BIDDING AND CONTRACT REQUIREMENTS
ADDENDUM NUMBER 2

Architect's Project Number:
224151.00

Re: **Addendum Number 2 to the bidding documents for:
Moline – Coal Valley School District #40
Browning Field Concessions and Toilet Room Improvements**

1 ROOF FRAMING PLAN
1/8" = 1'-0"

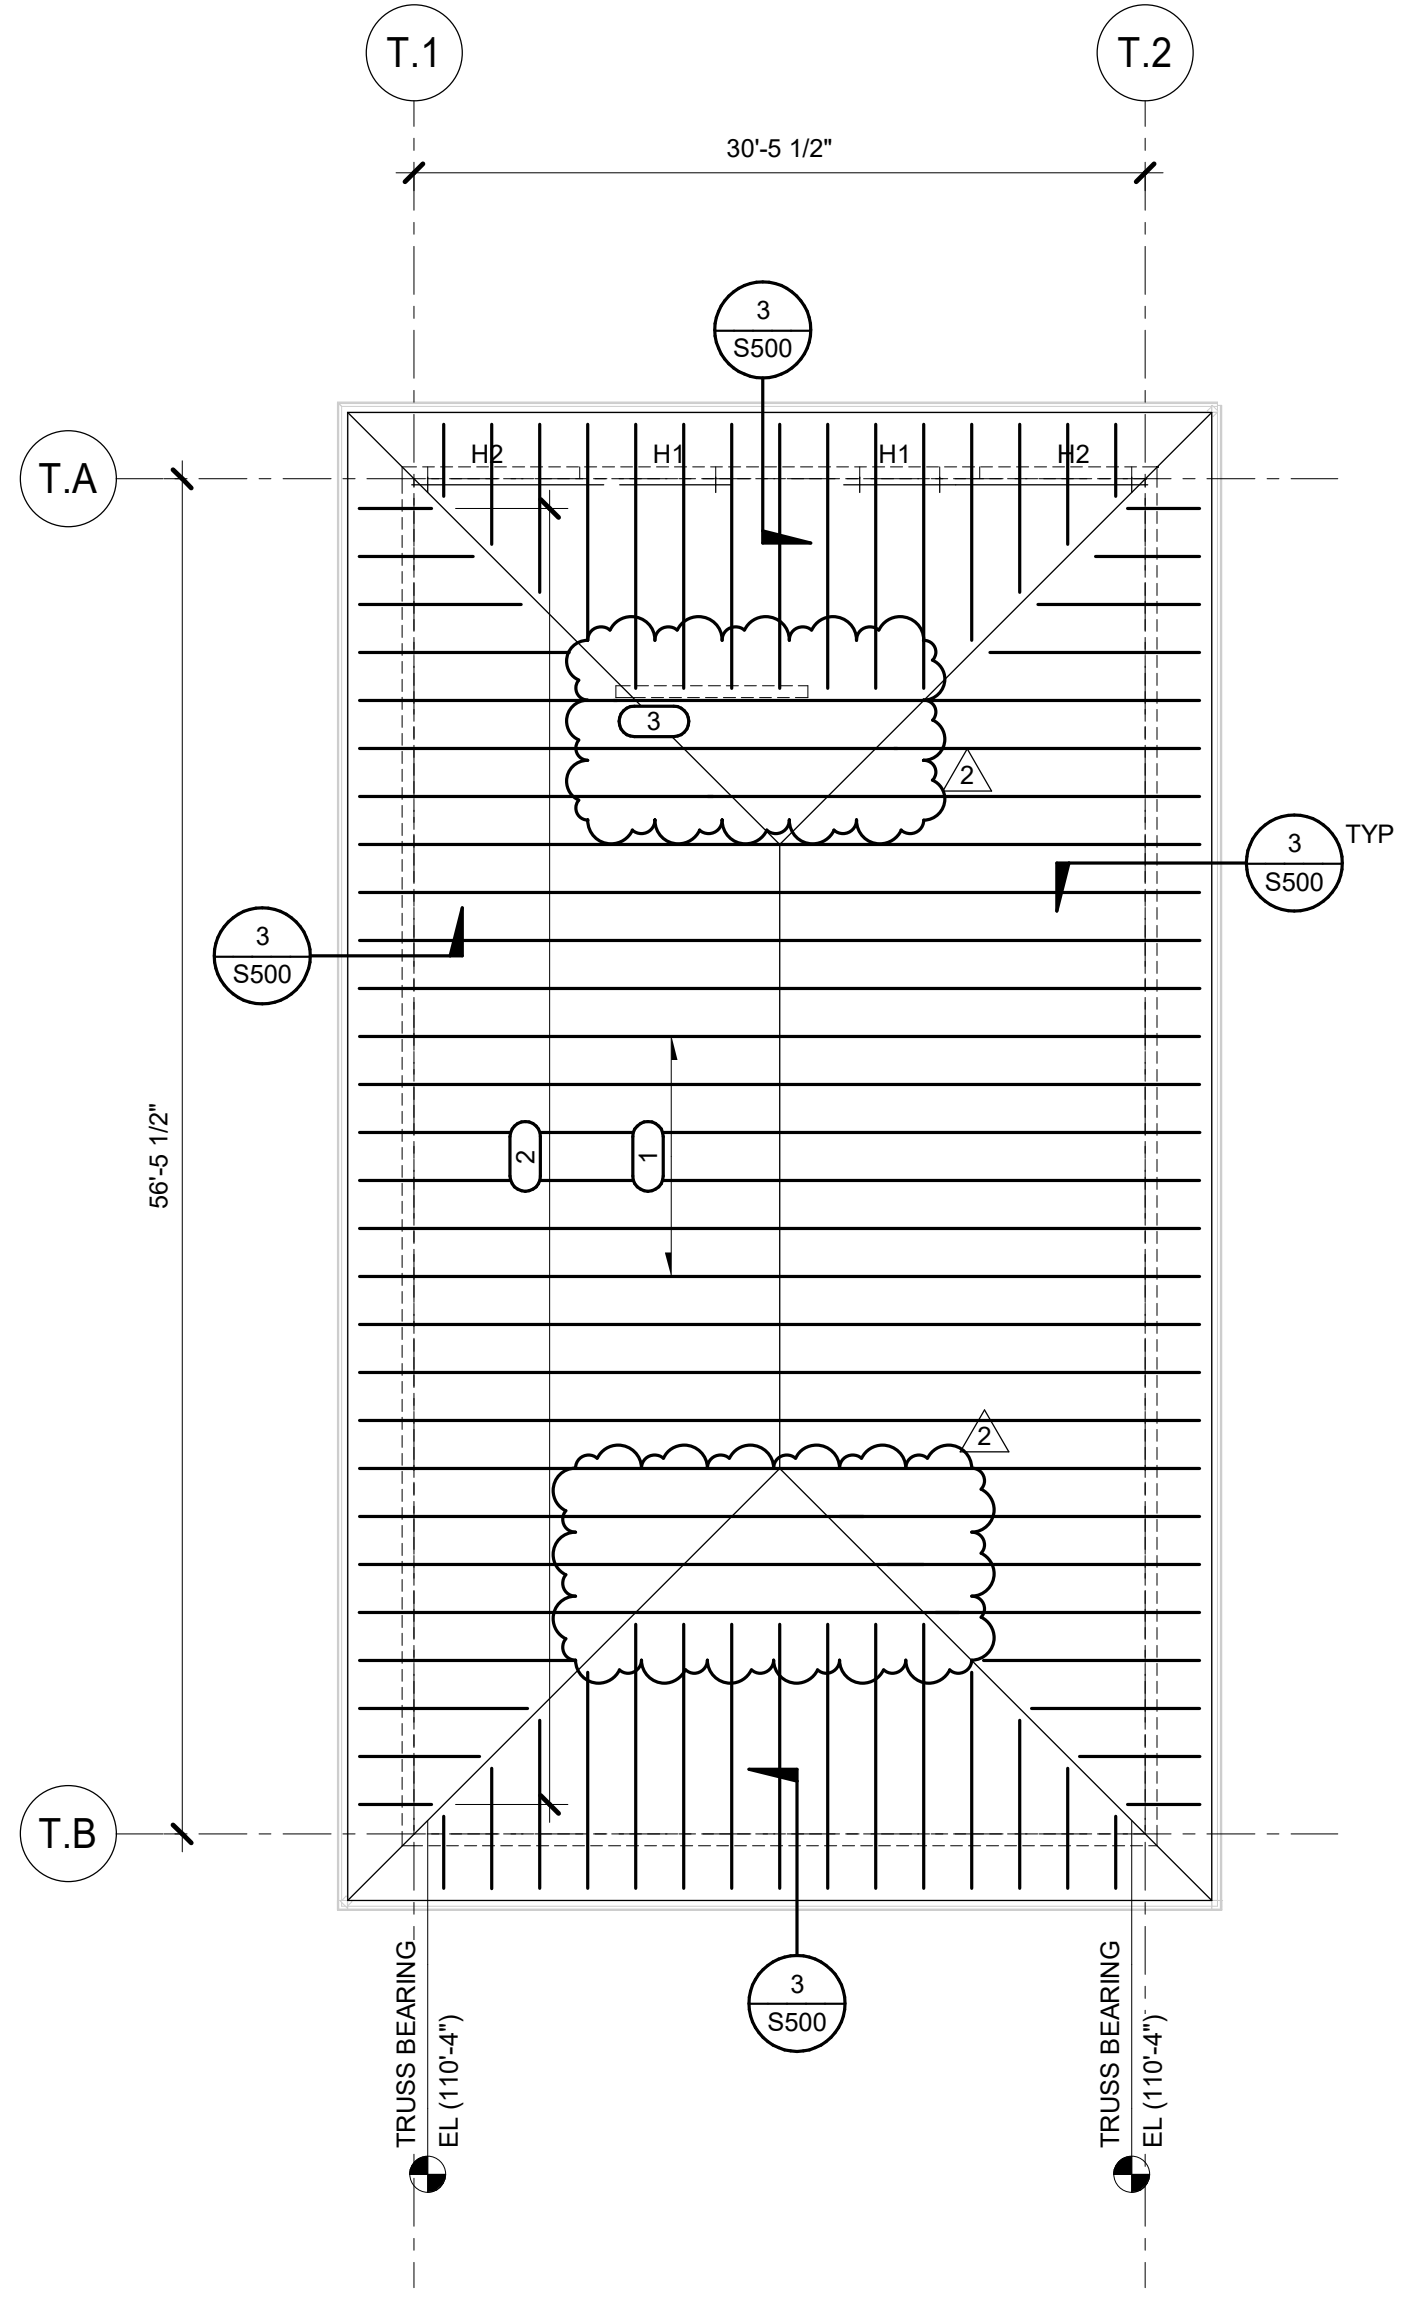
E. Drawing S101, titled, **ROOF FRAMING PLANS.**

1. **REVISE** roof truss profiles.
2. **REVISE** sheet notes.
3. **ADD** Keynote 3.
4. **REVISE** truss framing.

3 SLAB ON GRADE CONSTRUCTION
3/4" = 1'-0"

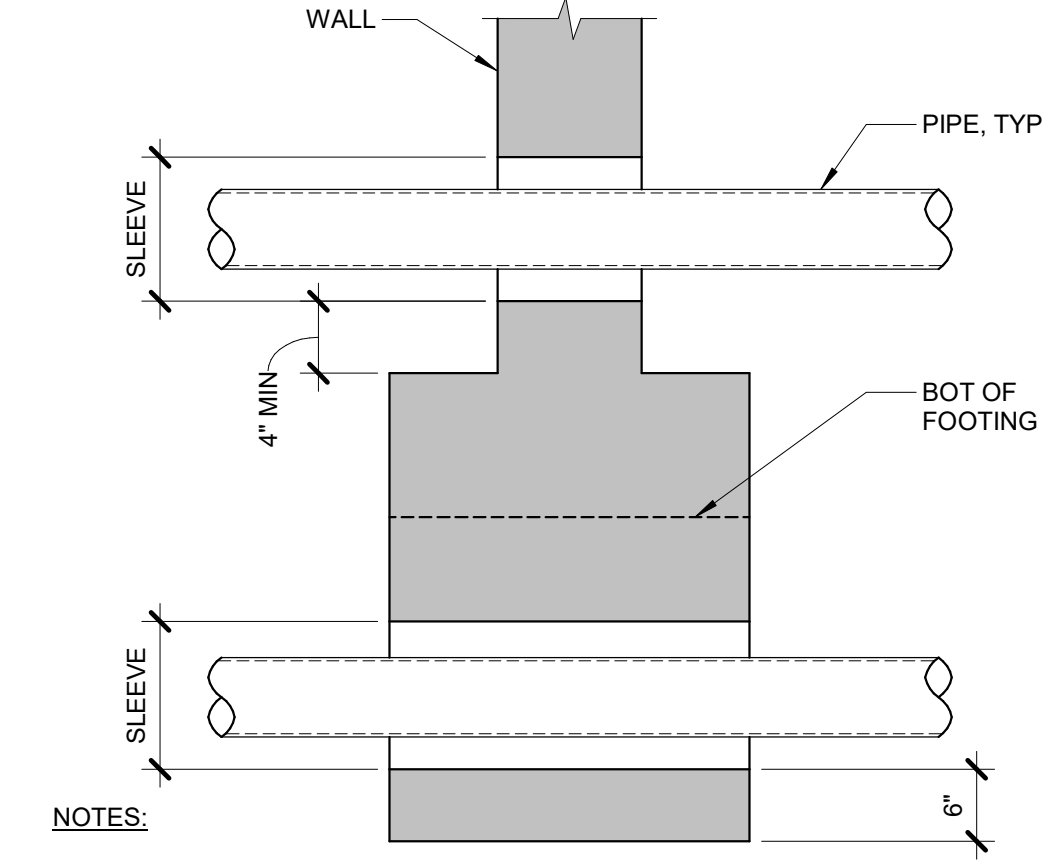
F. Drawing S300, titled, **CONCRETE DETAILS.**

1. **REVISE** detail 3, 5, and 11

2 EXTERIOR WALL
HEADER CONNECTIONS
3/4" = 1'-0"
S_CF-004

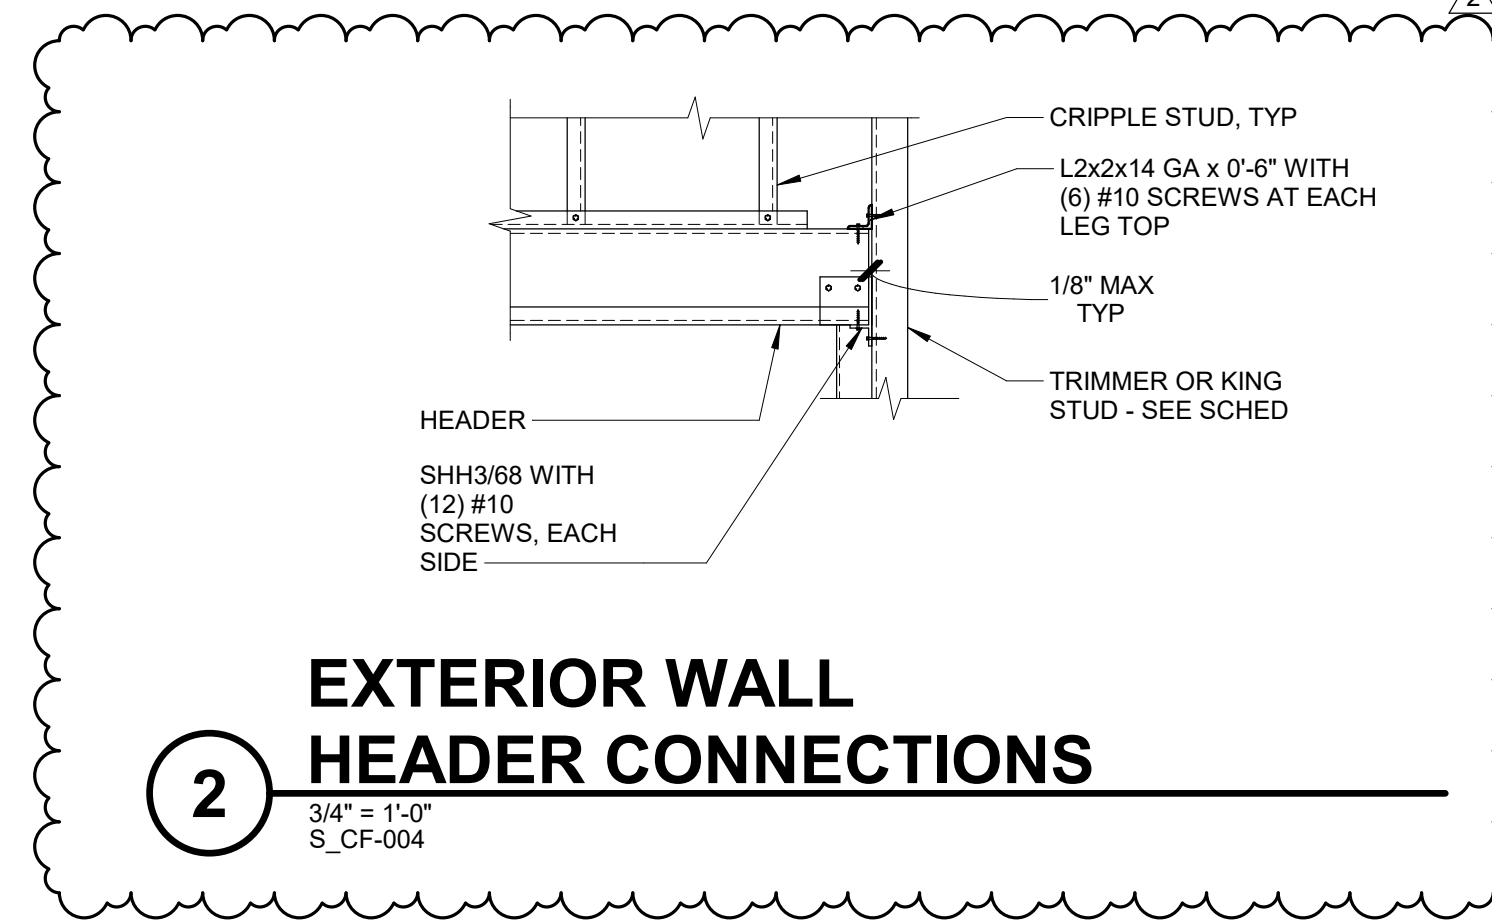
G. Drawing S400, titled, **COLD FORM STEEL FRAMING DETAILS.**

1. **REVISE** detail 1, 2, 7 and 9.

3 TRUSS BEARING AT EXTERIOR WALL DETAIL
3/4" = 1'-0"
S_W-202

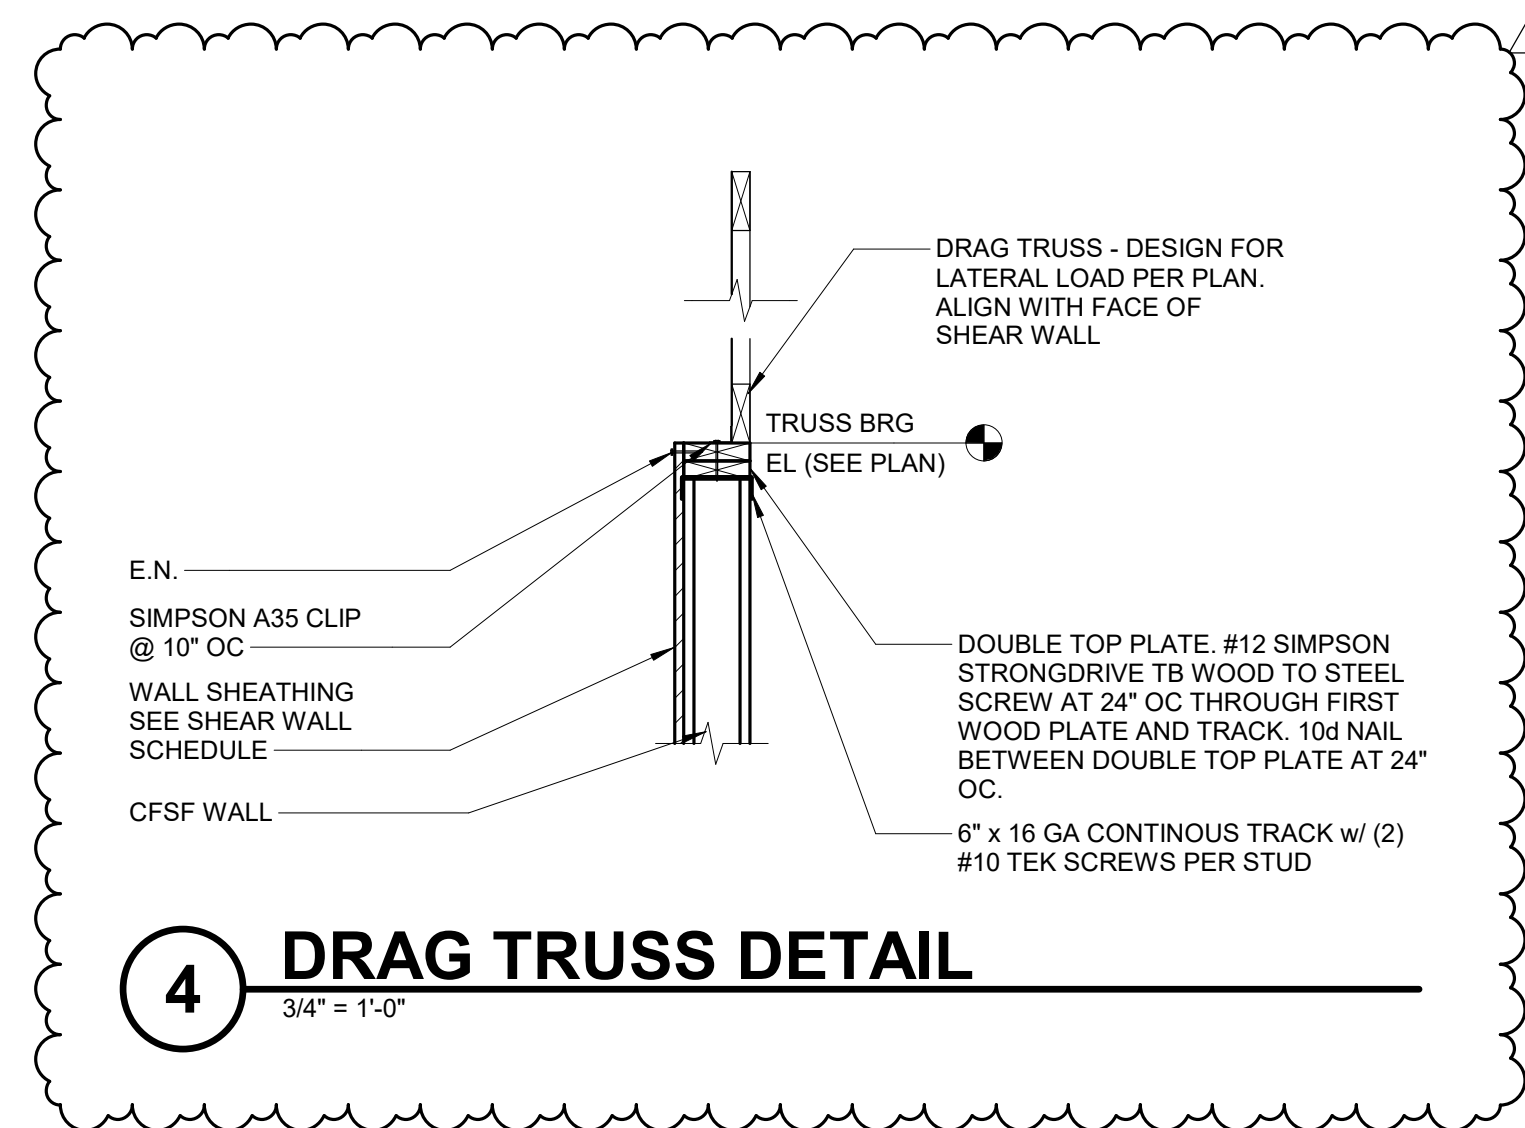
H. Drawing S500, titled, **WOOD DETAILS.**

1. **REVISE** detail 3.
2. **ADD** detail 4.
